UNITED STATES PATENT AND TRADEMARK OFFICE

APPLICATION NO.	FILING DATE	FIRST NAMED INVENTOR	ATTORNEY DOCKET NO.	CONFIRMATION NO.
09/832,530	04/11/2001	Alain Dunand	33441	1249

Office Action Summary

DETAILED ACTION

FIG-1

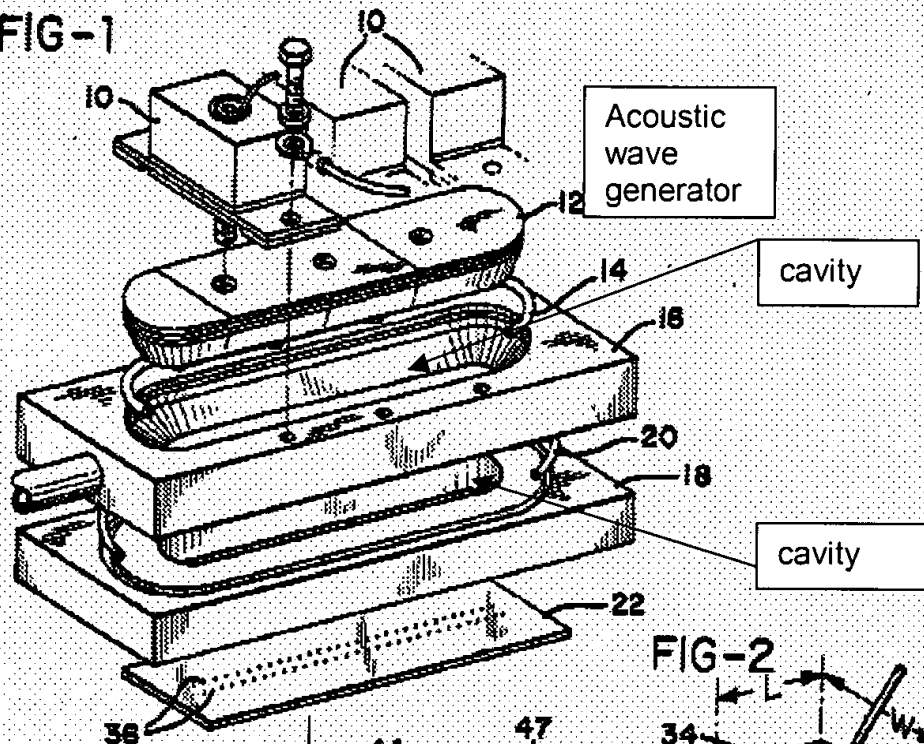
Cha et al. discloses an ink drop generator for an ink jet printer comprising :

- A generator body (Fig.1)
- At least one acoustic wave generator (ig.1: element 12) with a body elongated in an axial direction to the ink jet (Fig.1), each generator having a vibrating surface (The surface of the element 12) perpendicular the axial direction of the jets, at least one section comprising the vibrating surface of each acoustic generator being housed in a housing of the drop generator body (Fig1)

- One resonance cavity (Fig.2) intended to contain ink, a first section only of each cavity being constituted in a main section of the generator body and in this configuration, a second section in a continuation of the generator body connected to be leaktight to the generator body, each cavity hahing an ink feed, each cavity being defined particularly by a nozzle plate (element 22) and a wall, the intersection of the wall and the nozzle plate defining a first plane contour line of the wall, the nozzle plate comprising a plurality of nozzles aligned along an axial direction of the nozzles perpendicular to the axial direction of the jets (Fig.1; element 36)

- A generator characterized in that the wall of each cavity is perpendicular to the nozzle plate (element 22), the first contour line being formed by two equal segments that parallel to one another and the axial direction of the nozzles, each segment having two ends: a first and a second end, the two first ends of each segment being connected by a first curved line and the two second ends of each segments being connected by a second curved

line (when the nozzle plate, the manifolds 18 and the transducer holder are stack on each other, the contour is obtained).

- The curved line is concave toward the inside of the cavity (Fig.1)
- The first and second curved lines are constituted by semicircles the diameter of which is the space between the two equal segments (Fig.1).
